Re: Clarksburg Town Center
Revisions To Street Sections

SUBJECT: Stringtown Road Extended -- from MD 355 to I-270 (CIP Project No. 509337)
Traffic Operations Study (Revised) - Comments

Re: Clarksburg Town Center
Project Plan # 9-94004
Preliminary Plan # 1-95042
Waivers of MCDOT Roadway Standards and Closed Section Streets

RE: Project Plan No. 9-94004
Preliminary Plan No. 1-95042
Clarksburg Town Center

ALT. 2
FIGURE 5
2000 NO-BUILD INTERSECTION PROPOSED LANE CONFIGURATIONS
COM. PRO. MISE

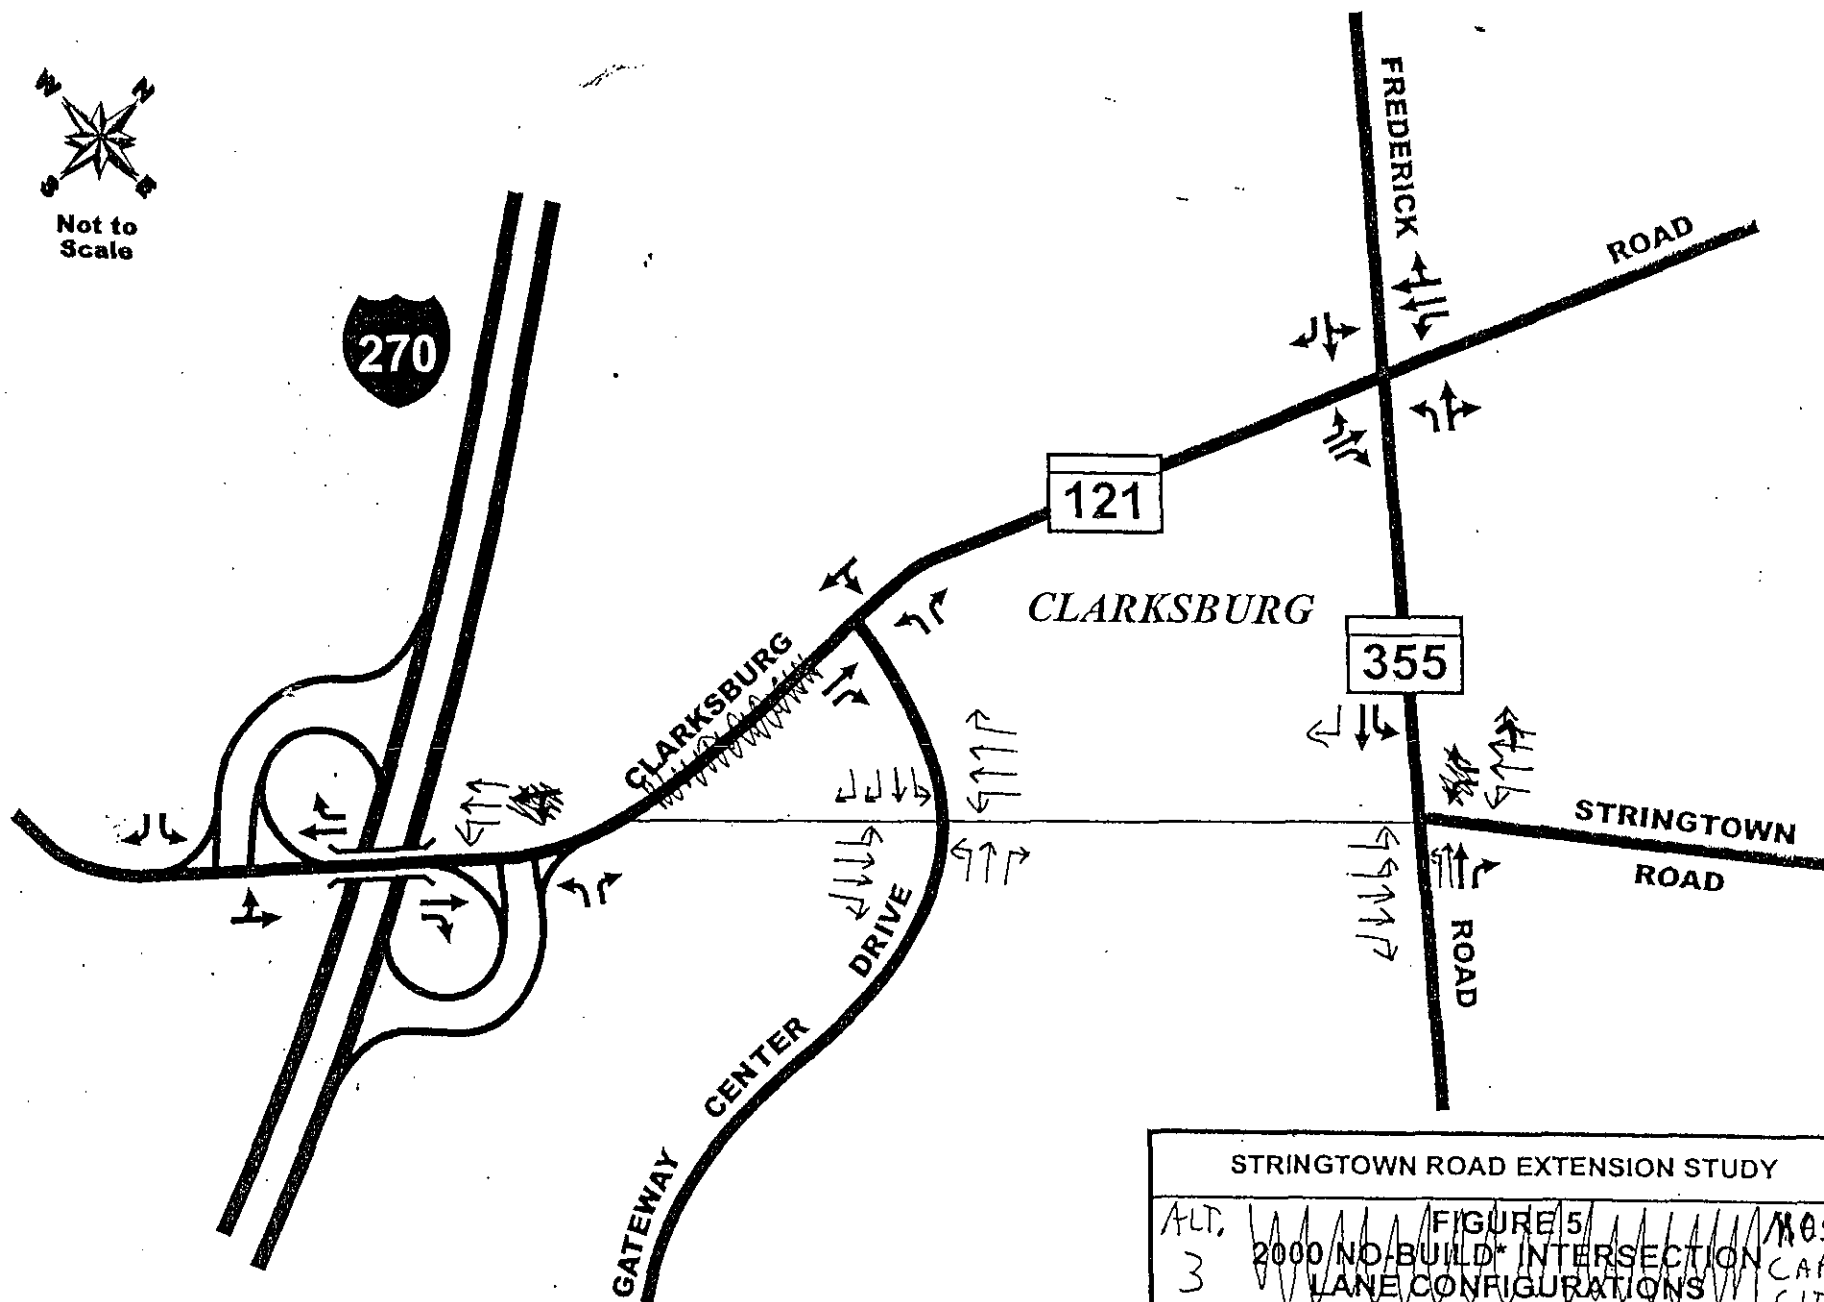
E- Based on "D" above, the Build Alternatives need to be revised. Also, what we really need to show decision-makers are the tradeoffs between environment and transportation (i.e., between protecting the Special Protection Area by minimizing lane pavement [impervious surfaces], and providing the most efficient and effective roadway network by maximizing traffic service). Therefore, the attached markups of the Year 2020 Lane Configurations figures from the revised study show the actual Alternatives needing testing:

- Alt. 1 – Least Natural Environmental Impact
- Alt. 2 – Environmental/Traffic Compromise
- Alt. 3 – Most Traffic Capacity
